SONORAN ENERGY PROJECT

Final Staff Assessment Part A for the Petition to Amend the Sonoran Energy Project (Formerly Blythe Energy Project Phase II) Decision

August 2016
CEC-700-2016-001-FSA

DOCKET NUMBER 02-AFC-1C

PROJECT DESCRIPTION - FIGURE 4b
Sonoran Energy Project - Site Plan / Layout

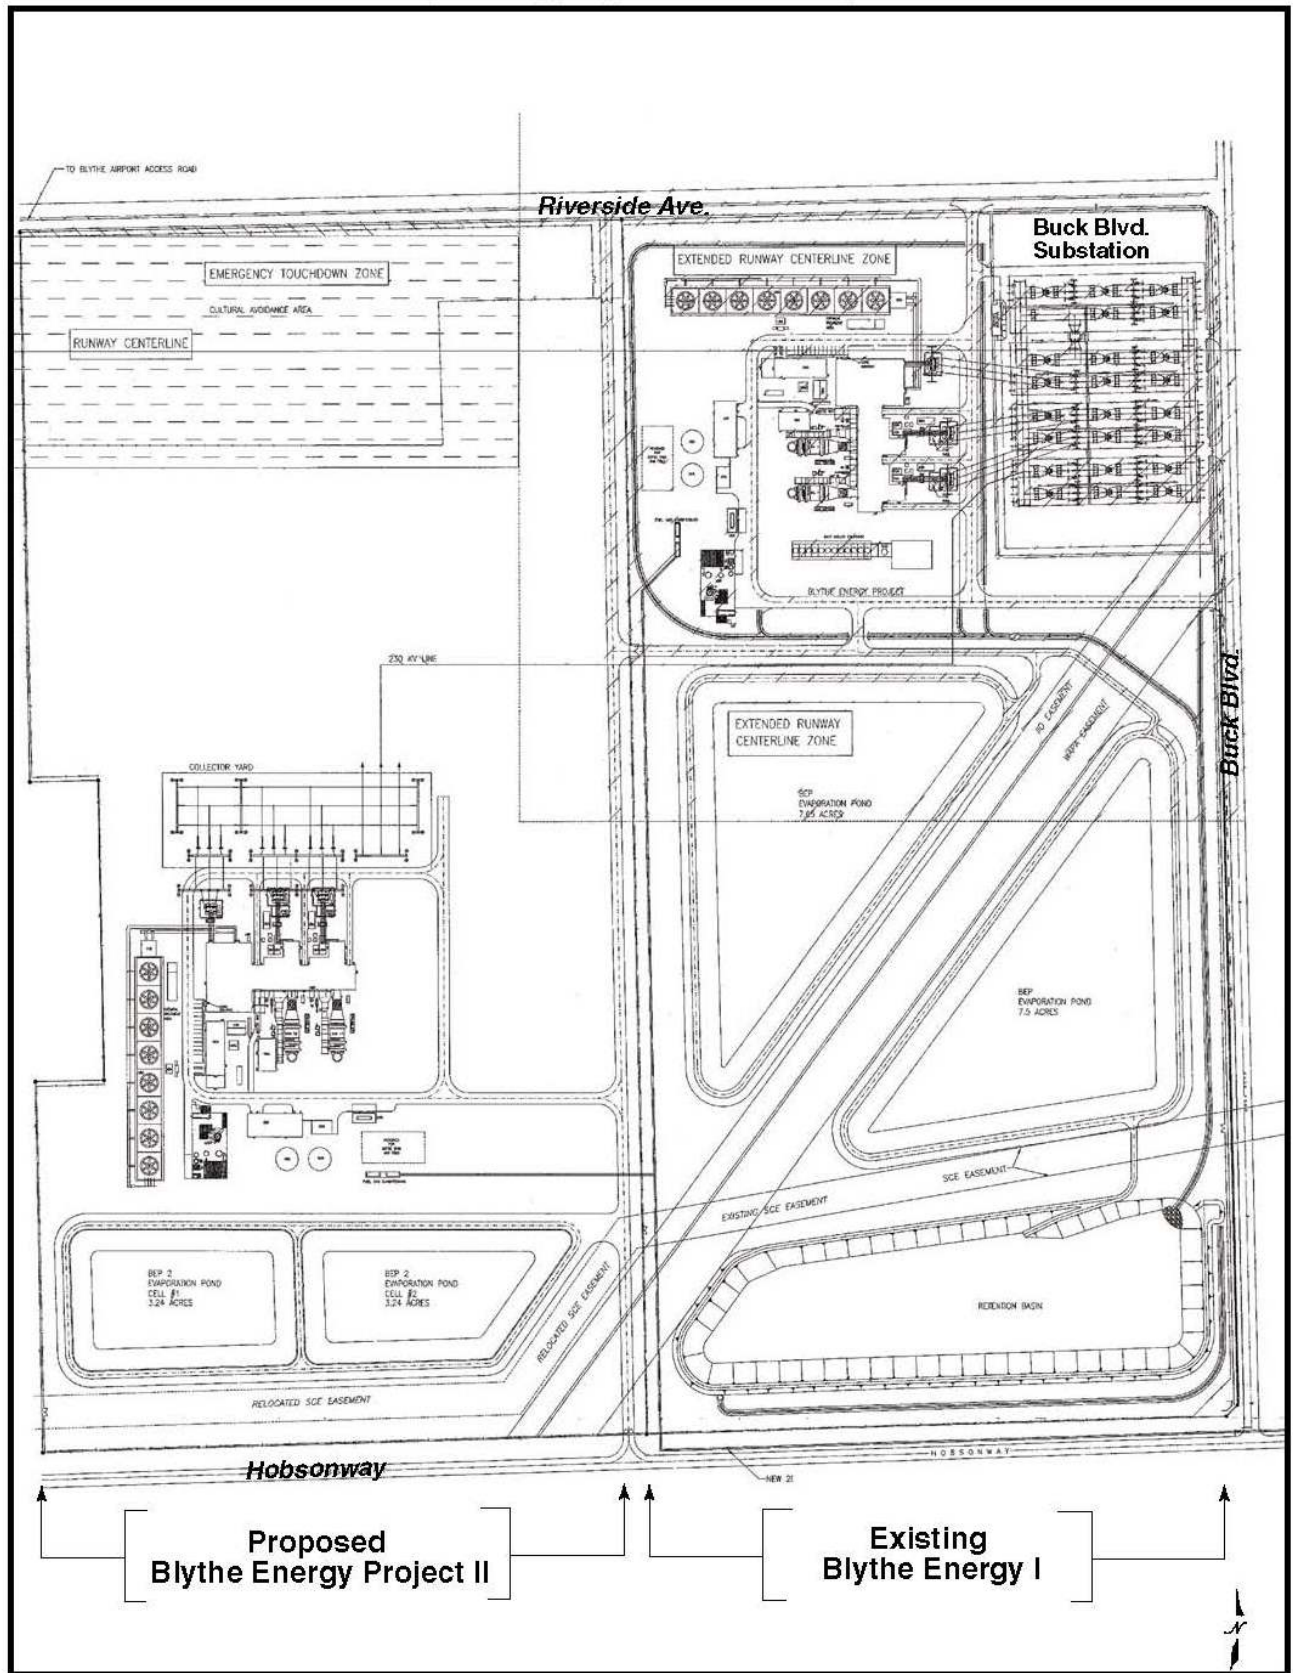
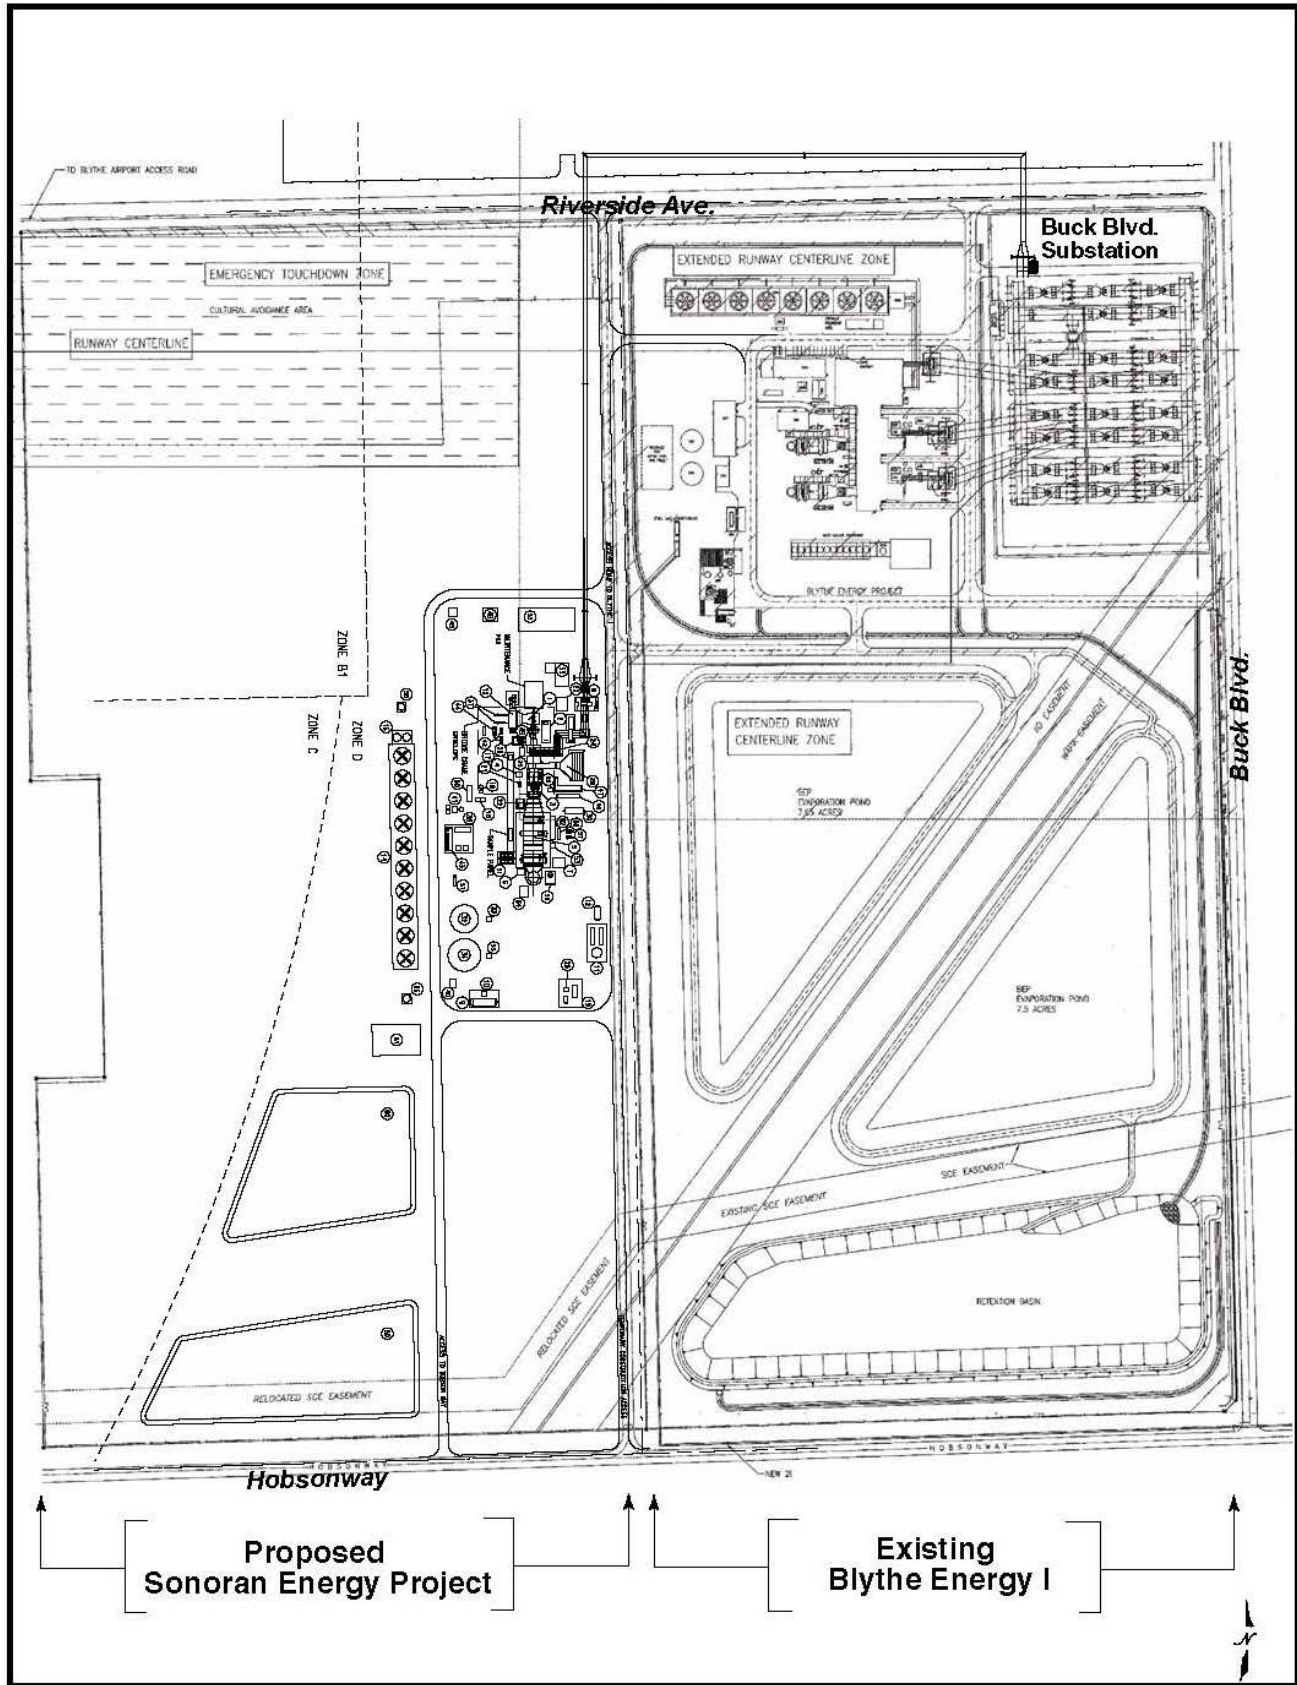
The SEP site boundary is located on an approximately 76-acre, previously disturbed site, immediately adjacent to the operational BEP, which is owned by Blythe Energy Inc. and operated by AltaGas Blythe Operations Inc. The SEP site boundary is the same as the BEP II; although the project layout of the SEP is different than the BEP II layout. **Project Description Figures 4a** and **4b** show the differences in the layout of the BEP II and the SEP and the site related to the existing BEP.

VISUAL RESOURCES - FIGURE 2b
Sonoran Energy Project - Revised KOP 1- Eastbound Highway 10 - Simulated View

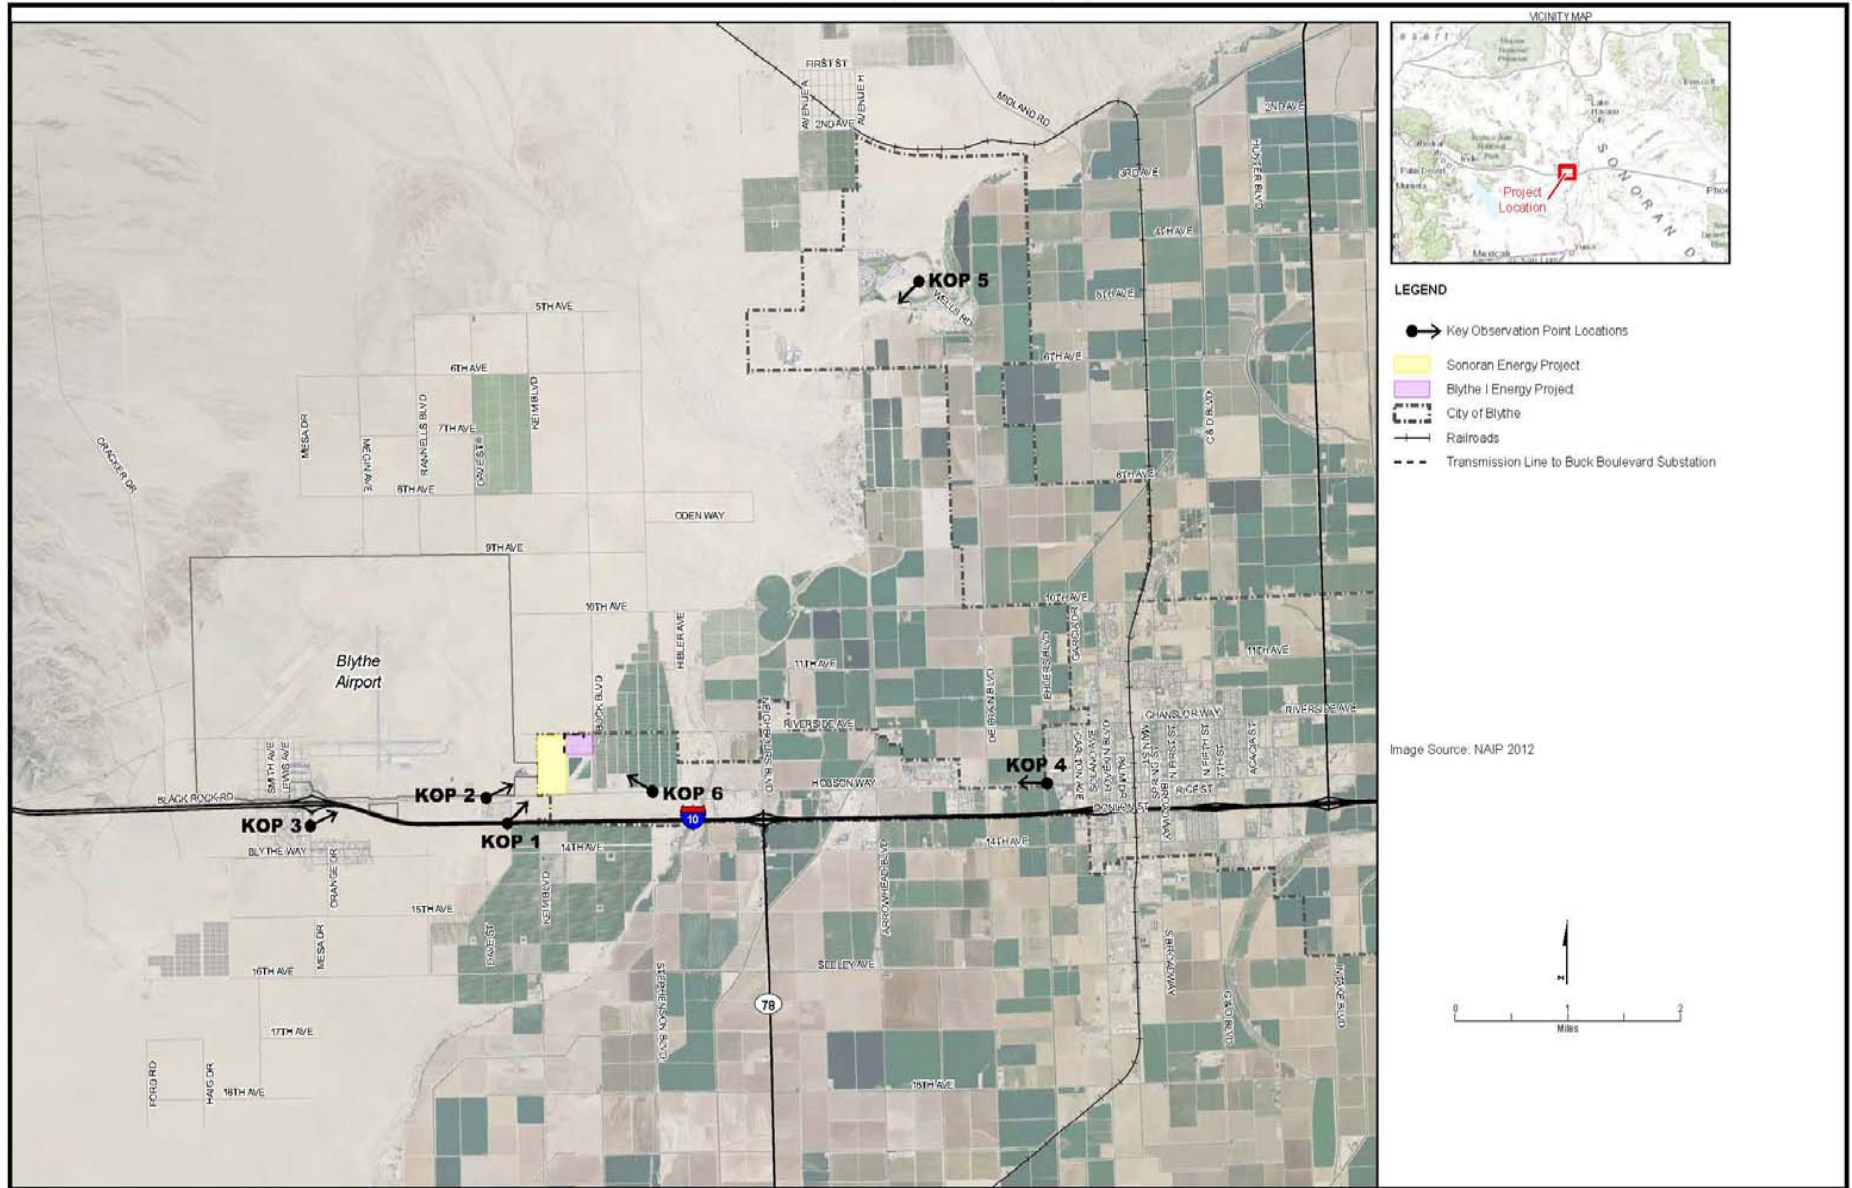
The revised simulation for KOP 1 depicts the proposed SEP power block to the right of BEP (**VR Figure 2b, Simulated View**). As depicted, the proposed SEP power block, HRSG exhaust stack, cooling tower, transmission lines and towers, and ancillary structures would be consistent with the lines and forms established by the existing BEP power plant; overall, the lines and forms of the SEP appear cleaner and more modern. The colors and materials of the proposed facility would be consistent with those of the existing power plant.

In comparison to BEP II (**VR Figure 2c, BEP II Simulation**), the proposed SEP would be visually similar to the licensed power plant facility, in terms of color, materials, and
